# YANKEE ATOMIC ELECTRIC COMPANY

October 1, 1986

Subject: SEP Topic III-5.A

## STEAM LINE WELDS

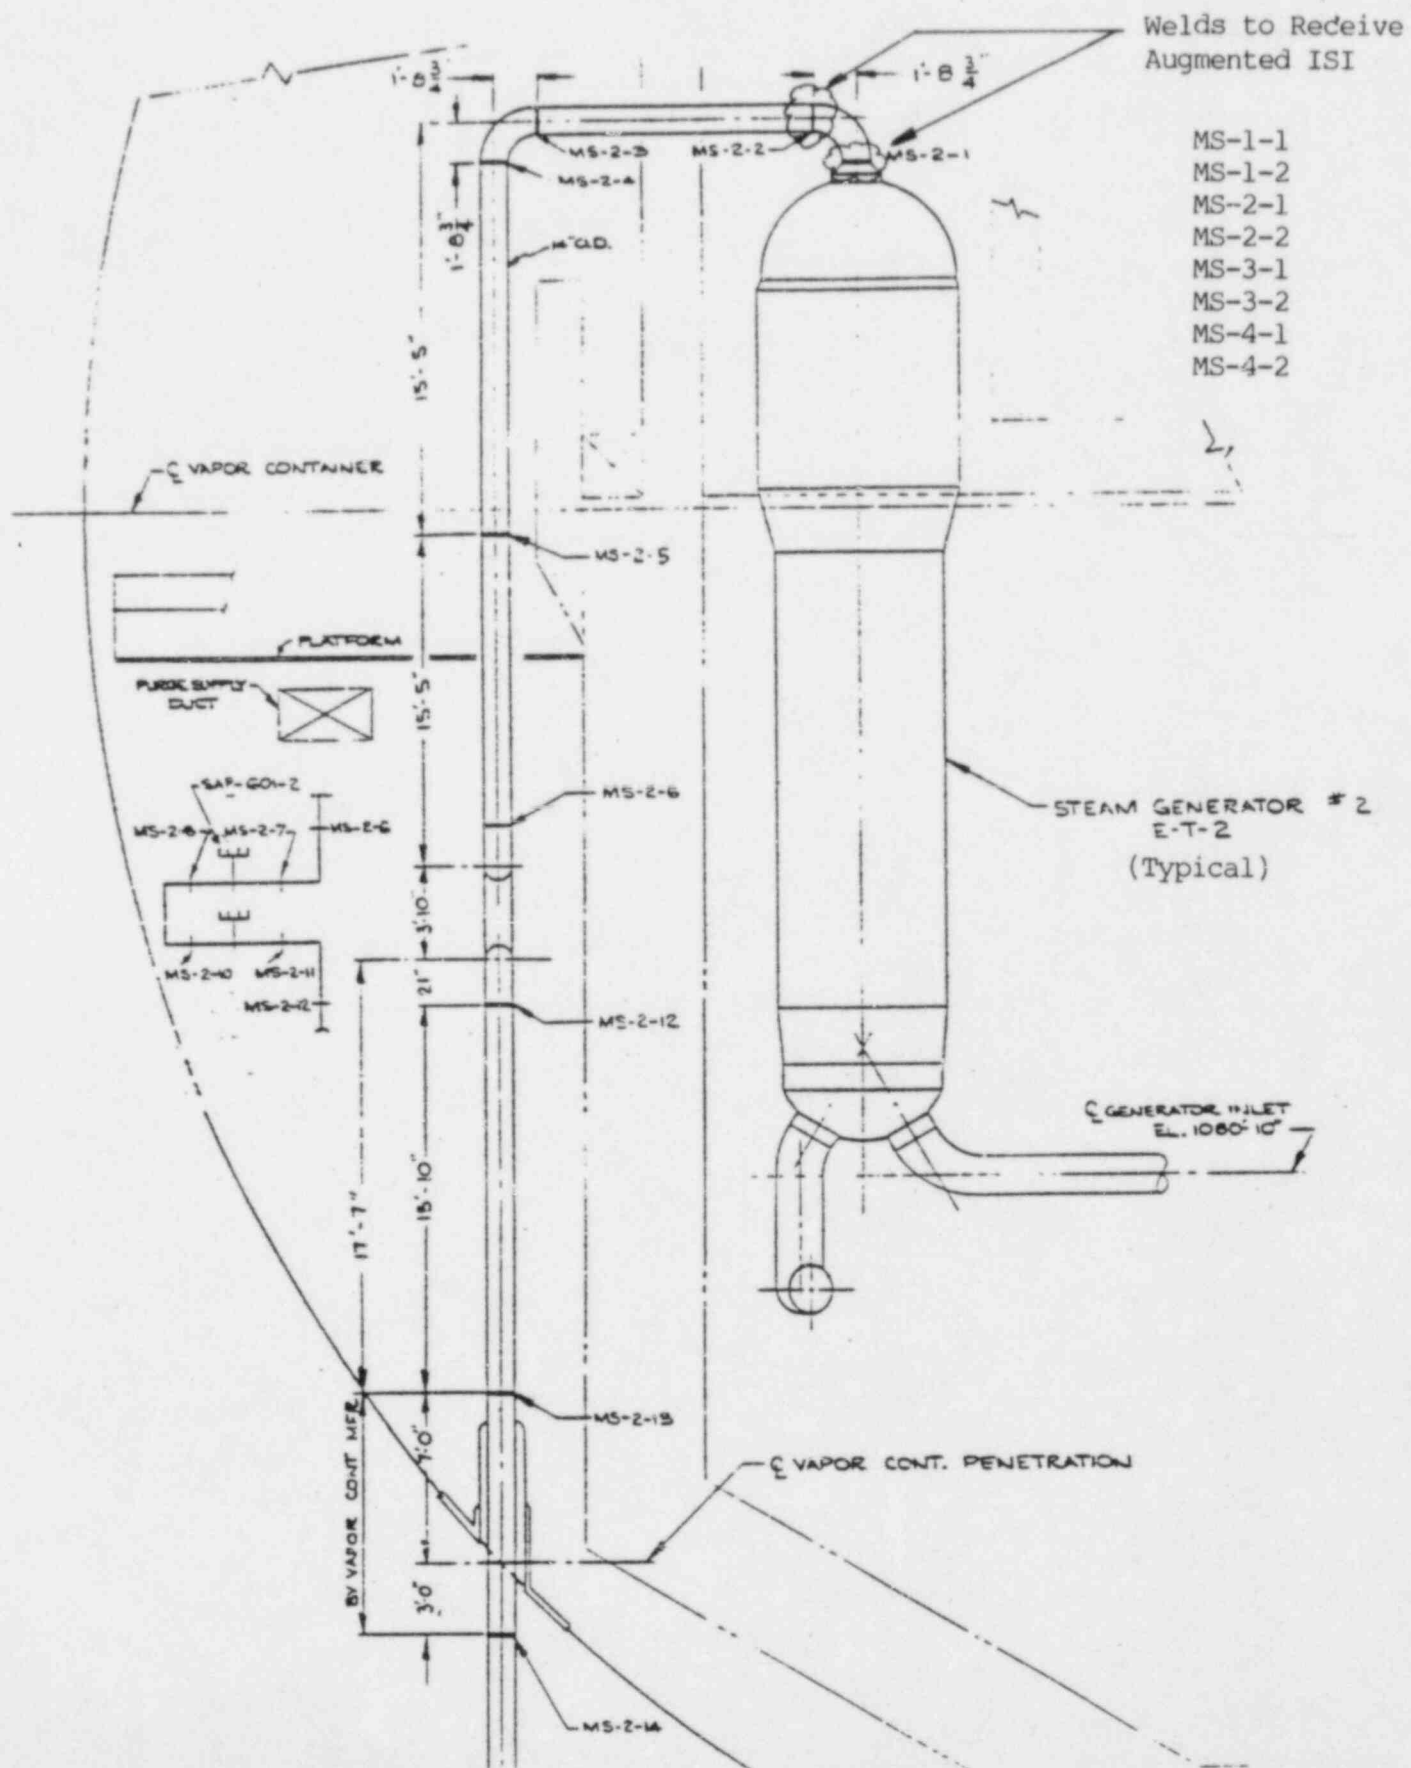
An analysis was performed to determine the force imparted on a steam generator from a horizontal break at the main steam outlet.

The results of this analysis indicate that the steam generator would not be capable of withstanding a horizontal load of the magnitude resulting from the postulated steam line rupture. Furthermore, design modifications are not practicable for the following reasons:

- (a) The postulated rupture of this line at this location is highly unlikely. The maximum computed stress in this line is well below the code allowable stress, using loads induced by the NRC site-specific seismic spectrum.
- (b) A pipe/component whip device would be required to resist the forces resulting from this postulated break. Installation of whip restraint mechanisms is contrary to the current NRC/industry position on these devices. It has been shown that these devices do not necessarily increase the overall safety of piping systems and components.
- (c) Yankee has installed an acceptable leakage detection system (Section 4.16 of NUREG-0825). If a leak were to occur, it would be quickly identified.

As an acceptable alternative, it is our position that an augmented Inservice Inspection (ISI) Program to inspect these welds be implemented (see Figure 1). We propose to inspect these welds on a one time basis during the 1987 ISI to ensure that this area of piping is acceptable per ASME Section XI criteria.
